ARCHITECT'S SUPPLEMENTAL INSTRUCTIONS

PROJECT - (name, address)	**SURGERY CENTER OF LEE'S SUMMIT** 1318 E. 104th St. Kansas City, MO 64131	**ARCHITECT'S SUPPLEMENTAL INSTRUCTION NO. - (6)**	**6**
OWNER -	**Hammes Partners** 1400 N. Water Street, Suite 500 Milwaukee, Wisconsin 53202	**DATE OF ISSUANCE -** April 29, 2024	
TO - (Contractor)	**JE Dunn Construction** 1001 Locust St Kansas City, MO 64106	**ARCHITECT -**	ACI Boland, Inc. 1710 Wyandotte Kansas City, MO 64108
CONTRACT DATED -		**ARCHITECT'S PROJECT NO. -**	3-22030

Description -
ASI 06 captures changes to the documents that support RFI responses, specifically regarding RFI 46. Which include modifications to the exterior canopies to conceal the dry-pipe sprinkler system. In addition, interior changes include mock-up changes to the OR's, Scope Processing area, Sterile Assembly, and Prep/Recovery Bays.

1 FIRST FLOOR SPECIAL SYSTEMS PLAN OVERALL
SCALE: 1/8" = 1'-0"

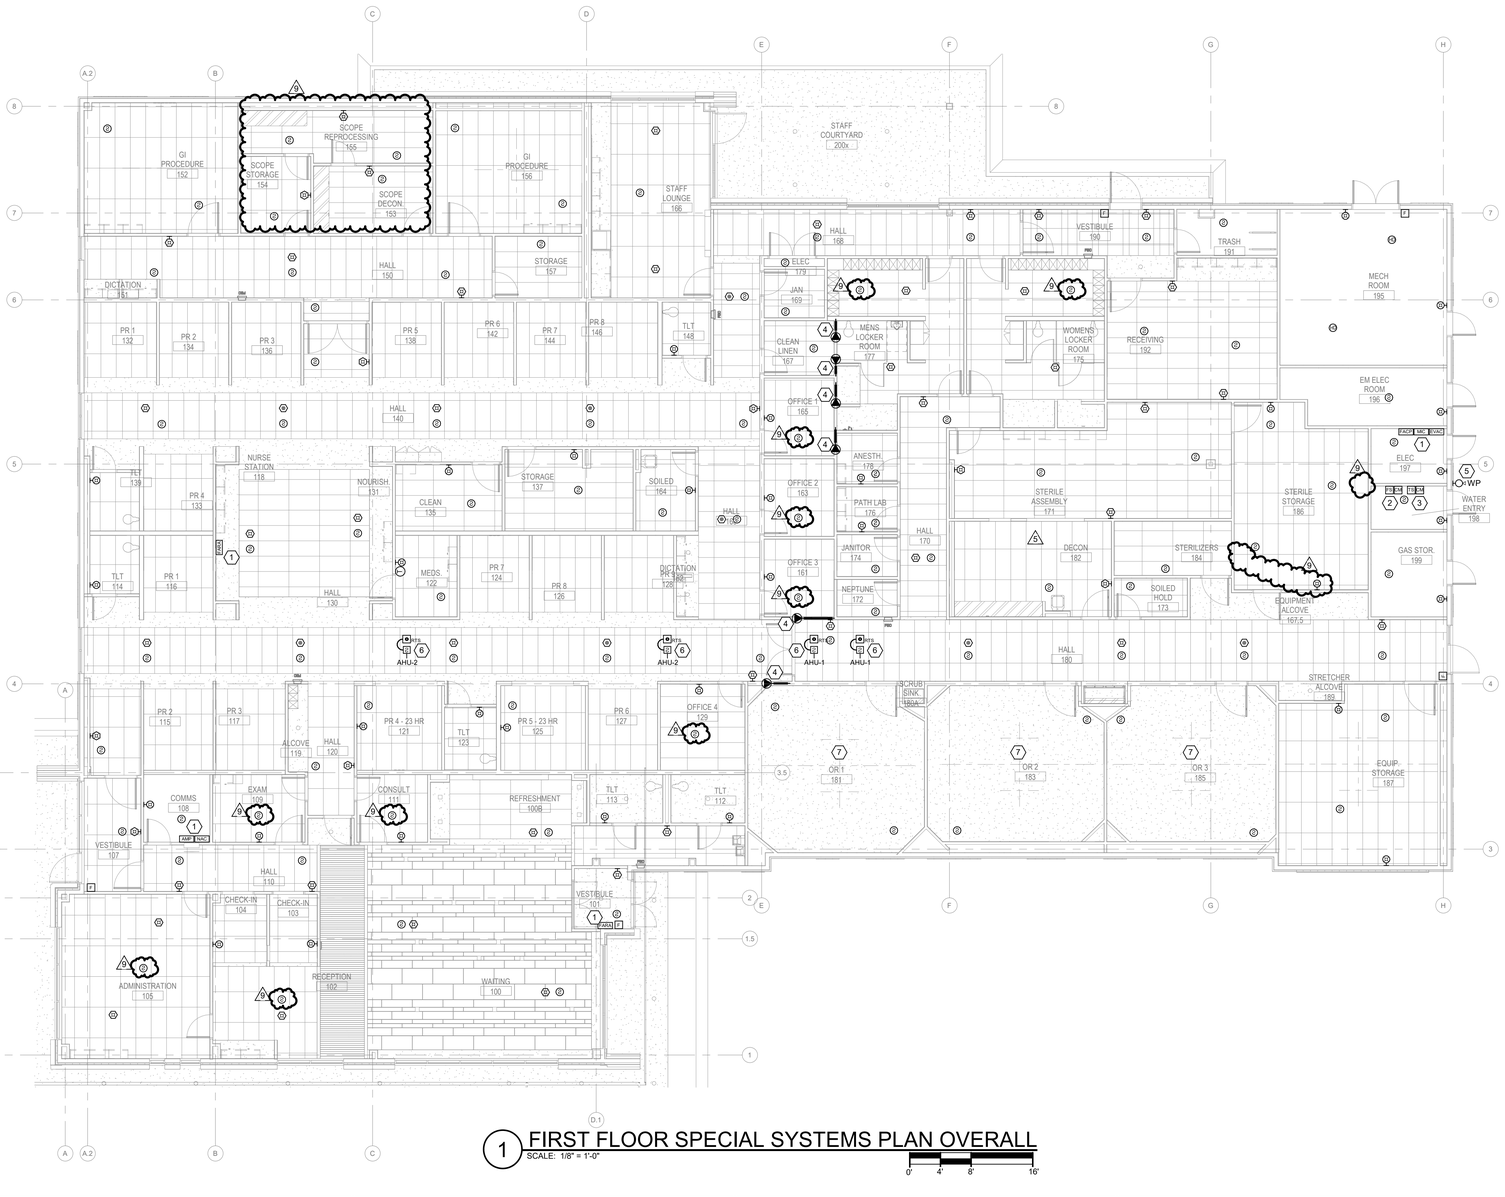
a. Added smoke detectors in Reception 102, Administration 105, Exam 109, Consult 111, Office 129, Office 161, Office 163, Office 165, Women Locker 175, Men Locker 177.
b. Revised location of strobe in Sterile Storage 186.
c. Removed strobe in Sterile Storage 186.
d. Revised location of devices in Scope 153, 154 & 155.

1 FIRST FLOOR TECHNOLOGY PLAN OVERALL
SCALE: 1/8" = 1'-0"

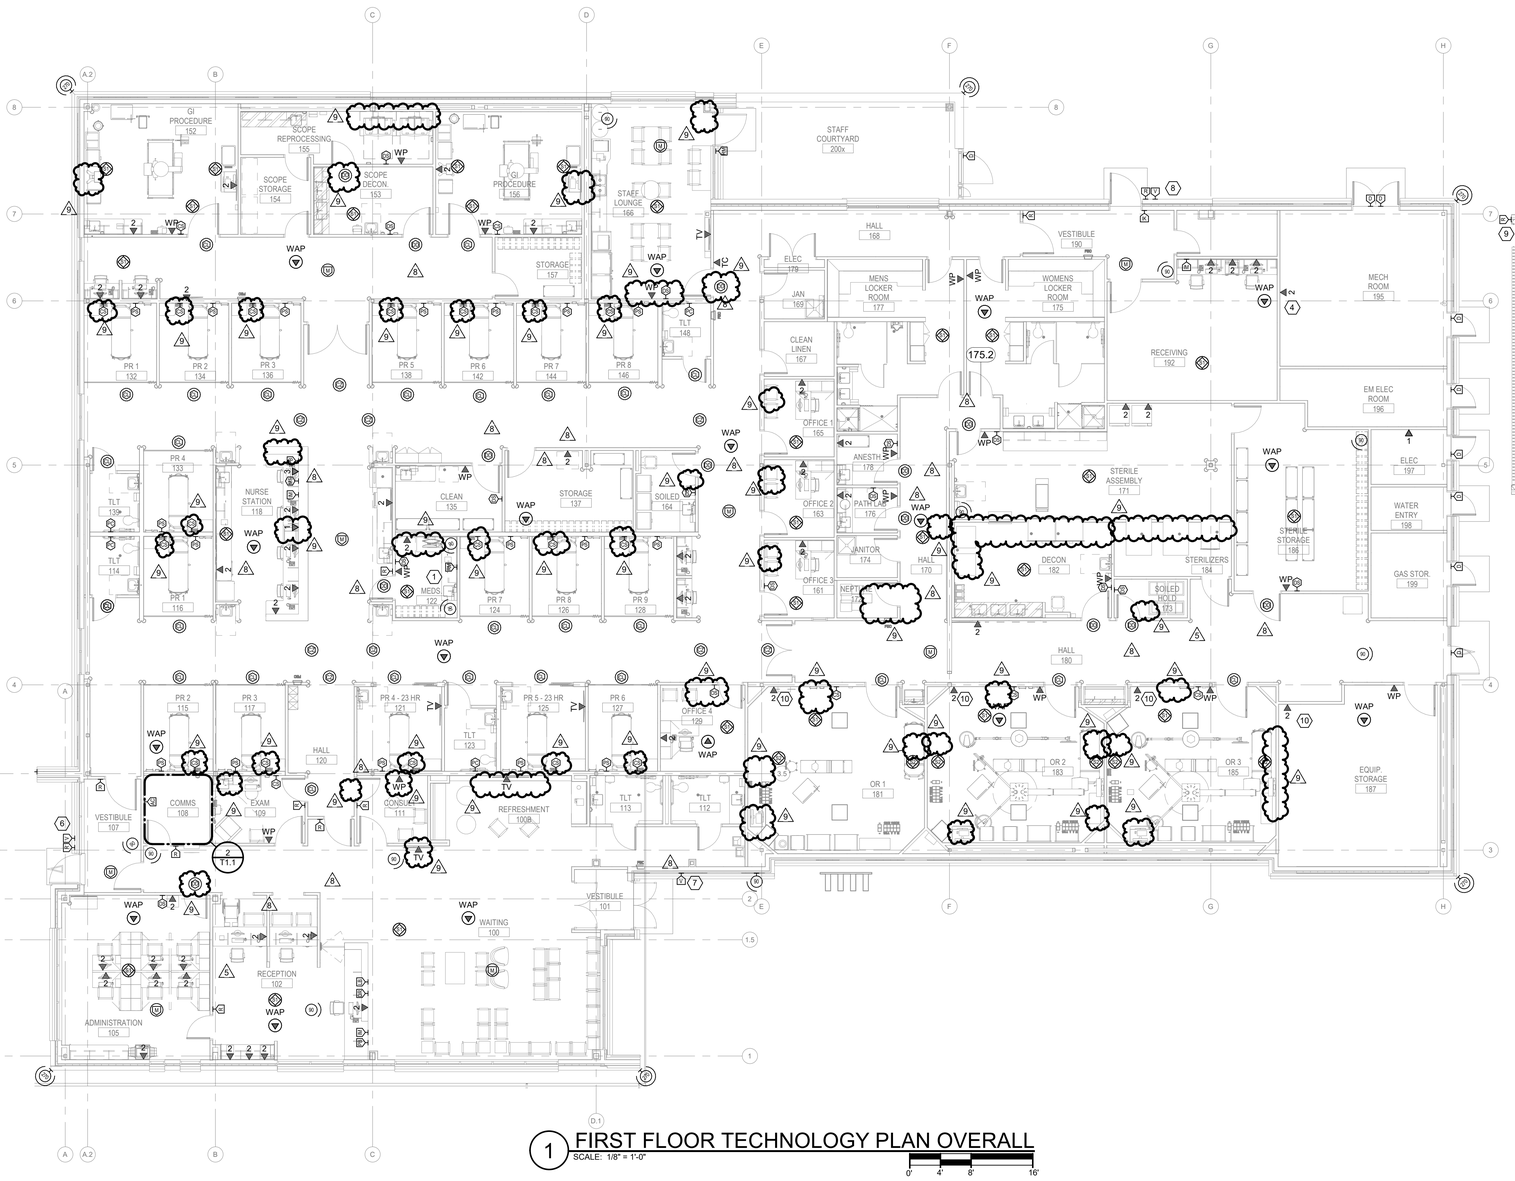
a. Added "DD" nurse call device outside of Administration 105.
b. Removed dual data drop from Exam 109.
c. Removed "CL" nurse call device outside of Consult 111.

d. Replaced dual data drop with wall phone in Consult 111.
e. Added TV outlet location to corridor side of south wall of Consult 111.
f. Removed (1) TV outlet location from Refreshment 100B and centered remaining TV outlet.

g. Removed dual data drop from Office #4 129 and added "DS" nurse call device.
h. Removed wall phone from Soiled 164.
i. Added "CS" nurse call device to all patient recovery rooms.

j. Removed dual drop from Nuse Station 118 and added single data drop centered in desk area.
k. Removed (2) dual data drops from Meds 122.
l. Removed dual data drop from GI Procedure 152.

m. Removed (3) dual data drops from Scope Reprocessing 155.
n. Added "DD" nurse call device inside Scope Decon 153.
o. Removed dual data drop from GI Procedure 156.
